MEMORANDUM

From:	Chief Officer, Environment & Technical	**To:**	Chief Officer Economy & Planning
		FAO::	Sarah Duckworth
Our Ref:	ET/DC/DB/P/2025/0832 Res 2	**Your Ref:**	P/2025/0832
Date:	11/03/2026

PROPOSAL: GWEITHREDIADAU PEIRIANNEG I OSOD SYSTEM DDRAENIO NEWYDD A GOSOD CYNWYSYDDION LLONGAU A GWAITH TIRLUNIO / ENGINEERING OPERATIONS TO INSTALL NEW DRAINAGE SYSTEM AND THE SITING OF SHIPPING CONTAINERS AND LANDSCAPING WORKS

LOCATION: DARLAND SCHOOL AND SPORTS CENTRE, CHESTER ROAD, ROSSETT, WREXHAM, LL12 0DL

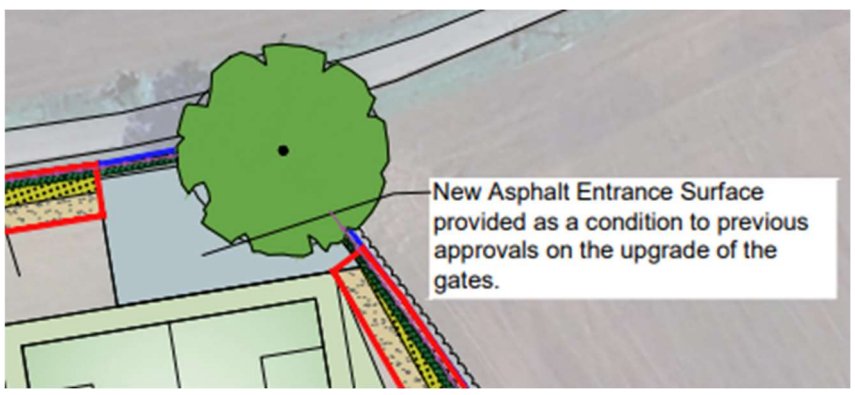
It is noted that the principle of this access is already approved via separate applications on the site, but it is just the safe management of the access that is being reviewed. Reference is made on the site plan to a new asphalt entrance. (The LHA accept the paving may need to be porous to safeguard roots to the adjacent mature tree.)
